**LEGISLATIVE COUNCIL
PANEL ON DEVELOPMENT**

**PWP Item No. 3185GK — Re-provisioning of Transport Department's
Vehicle Examination Centres at Tsing Yi**

**Follow-up Actions Arising from the Discussion
at the Meeting on 16 December 2016**

Site Constraints Diagram for The New VEC

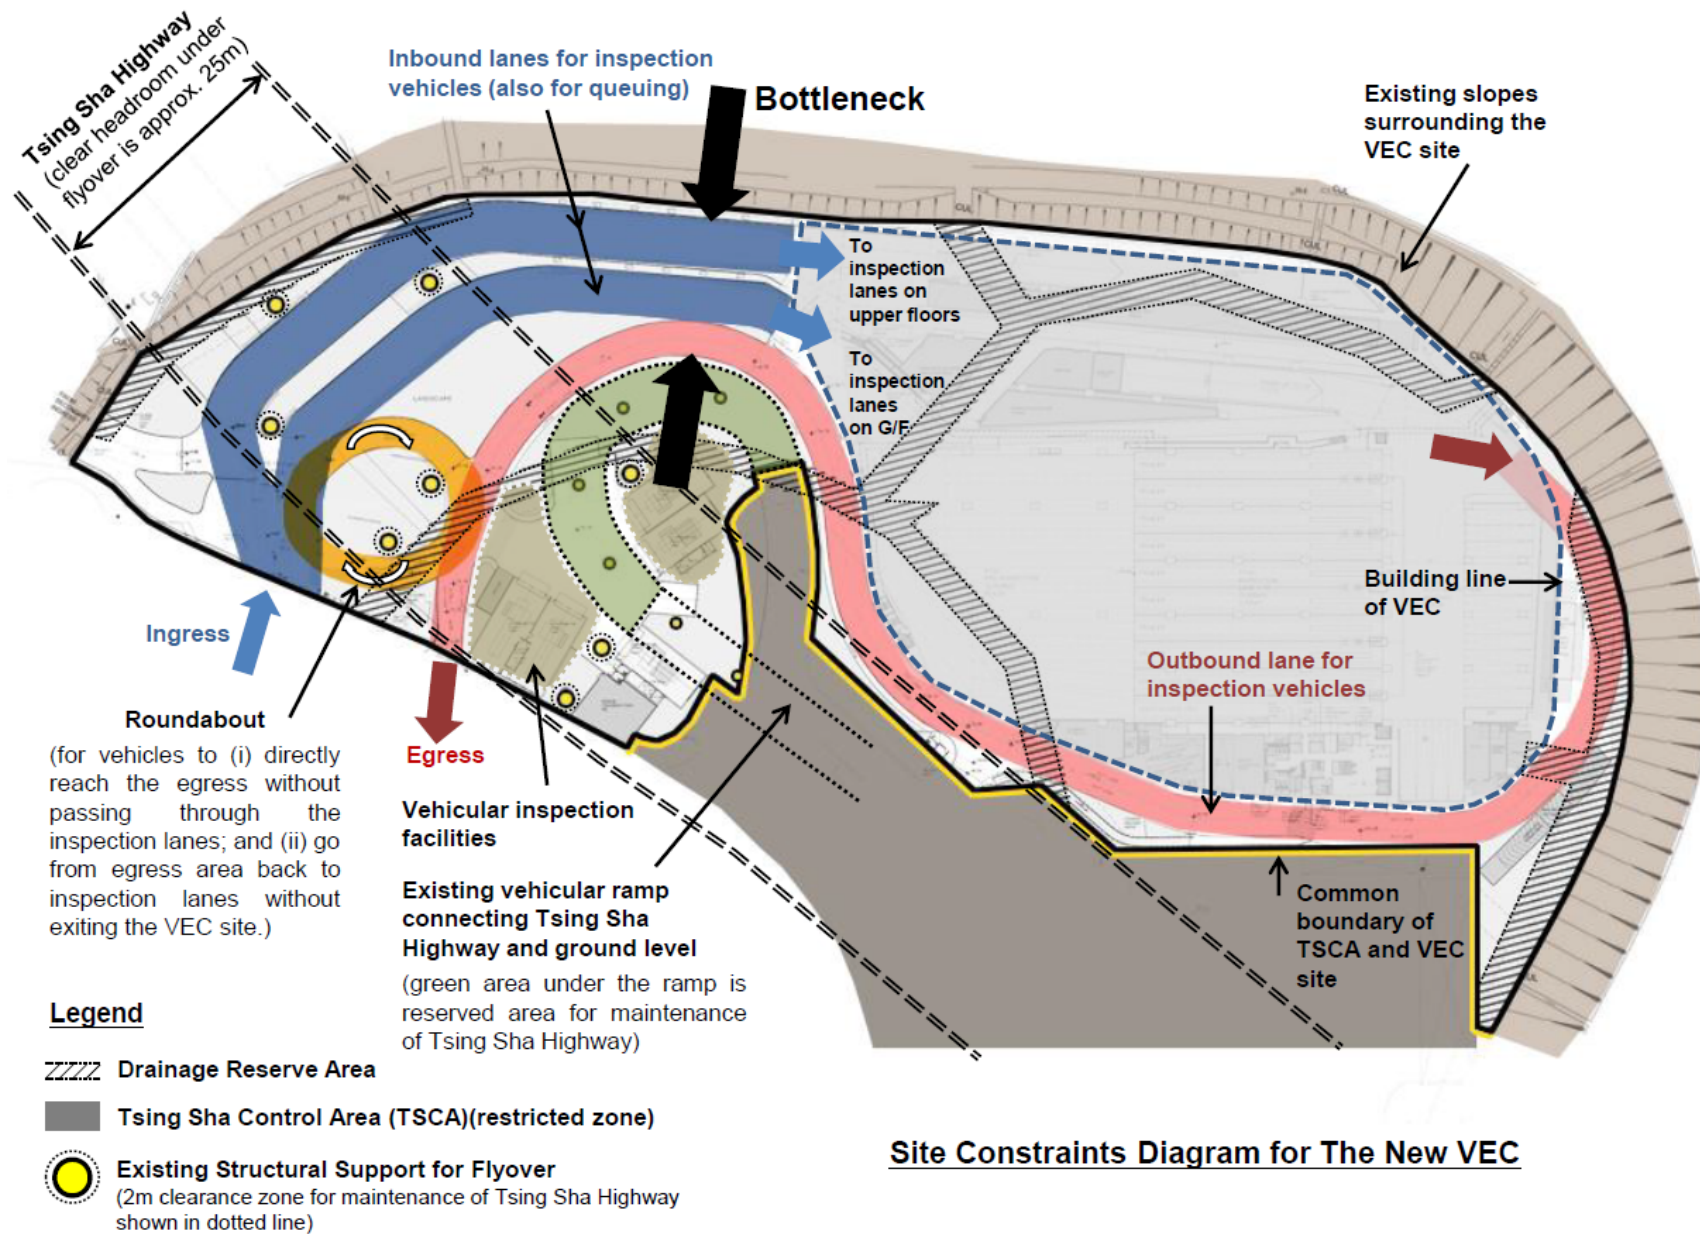
12. Moreover, in order not to adversely affect the normal operation and efficiency of the VEC, there should be separate site ingress/egress, dedicated vehicular lanes (including ramps), pedestrian access point, etc. for the public vehicle park. Having reviewed the site layout, no spare space on ground level can be identified to accommodate the above dedicated access requirements for the public vehicle park. The Tsing Sha Control Area (TSCA) adjoining the site also limits the creation of additional site ingress/egress along the common boundary. Above all, the bottleneck area near the middle of the site, which is occupied by the essential vehicular lanes, constitutes the major constraint.

13. In view of the lack of space on ground level, the feasibility of constructing a basement public vehicle park has also been explored. However, there are a large number of Drainage Reserve Areas running across the site which render it extremely difficult to incorporate a basement public vehicle park of a meaningful scale. It would also involve a large volume of rock excavation which implies a significant cost increase and a much longer construction period. Furthermore, deep excavation for basement construction may have implications on the stability of the slopes to the north of the site. The site constraints are shown in the diagram at **Appendix 2**.
